MIL-C-13516R
 AMENDMENT 5
~~24 February 1992~~
 SUPERSEDING
 AMENDMENT 4
 26 August 1991

MILITARY SPECIFICATION
 CIRCUIT BREAKERS, MANUAL AND
 AUTOMATIC (28 VOLTS DC)

This amendment forms a part of Military Specification MIL-C-13516R, dated 28 March 1979, and is approved for use within the U.S. Army Tank-Automotive Command, Departments and Agencies of the Department of Defense.

FIGURE 2b. Endurance test.

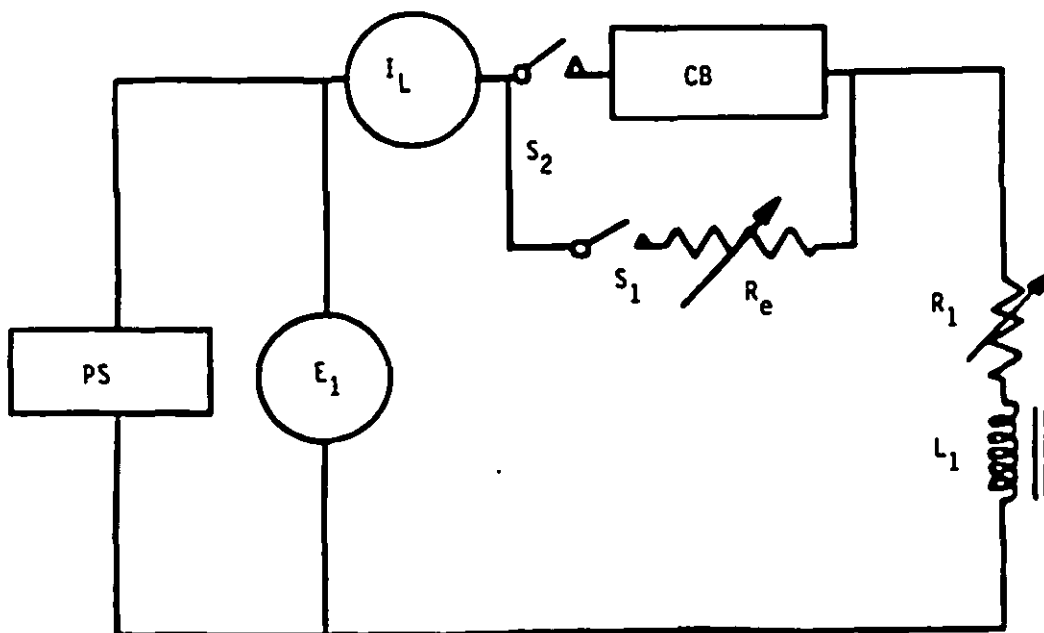
4.6.9.2 Alternate B. The circuit breaker shall be connected as shown in figure 2b. R_1 shall be adjusted to give the specified current. L_1 shall be an inductor conforming to type I, MIL-I-81023. When it is necessary to parallel inductors to achieve specified circuit breaker tests currents, paralleling shall be in accordance with MIL-I-81023."

Add new figure:
